विषय:IS 9873 (Part 4):2017 (Safety of Toys Part 4 Swings, Slides and Similar Activity Toys for Indoor and Outdoor Family Domestic Use) के amendment no. 1 के अनुपालन के दिशानिर्देश

Subject: Guidelines for implementation of amendment no. 1 to IS 9873 (Part 4):2017 (Safety of Toys Part 4 Swings, Slides and Similar Activity Toys for Indoor and Outdoor Family Domestic Use)

AMENDMENT NO. 1 FEBRUARY 2022

IS 9873 (PART 4): 2017/ISO 8124-4: 2014 SAFETY OF TOYS

Figure 4 — Diagrammatic representation of examples of swings

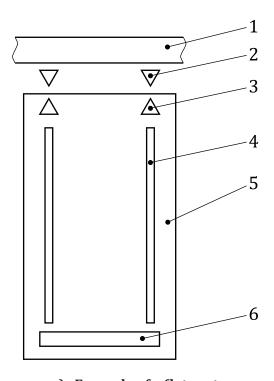
Figure 4 *Replace as follows.*

b) Example of a gondola

- 1 crossbeam/support member
- 2 suspension connector
- 3 suspension coupling
- 4 means of suspension
- 5 swing device
- 6 swing element (e.g. seat, rings, bar, gondola)

NOTE A swing device can include one or more footrests. Footrests are considered as parts of the swing elements
